ARTICLE: SLI-15-11-01

SUBJECT: SLINGSHOT – REAR SPROCKET RETAINING NUT RUNNING CHANGE

MODELS: ALL 2015-2016 SLINGSHOT MODELS

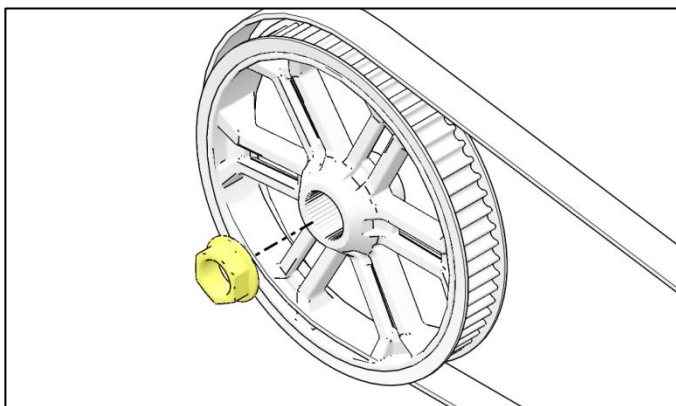
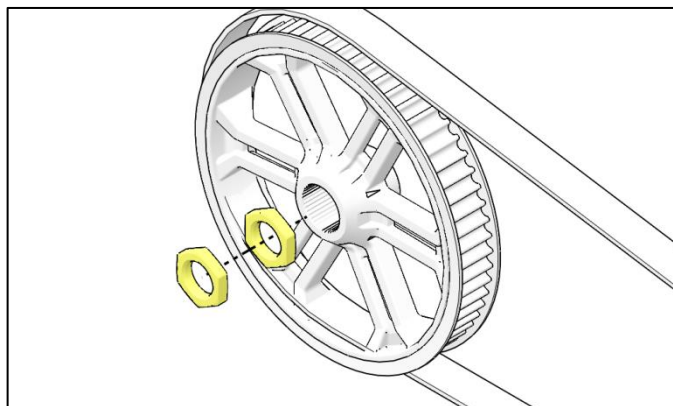
The Slingshot Division of Polaris Industries has developed updated rear sprocket retaining nuts and Loctite® on 2016 Slingshot models manufactured after 11/02/2015. The single hex flanged-style nut has been replaced with two hex head nuts. Loctite® 641 (Yellow) applied to the rear axle splines and threads has been replaced by Loctite® 680 (Green).

OLD (PN 7547617 – QTY 1)

TORQUE

250 lb-ft (339 Nm)

Loctite® 641 (Yellow)

NEW (PN 7547831 – QTY 2)

TORQUE

Inside Nut: 250 lb-ft (339 Nm)
Outside Nut: 150 lb-ft (203 Nm)

Loctite® 680 (Green)
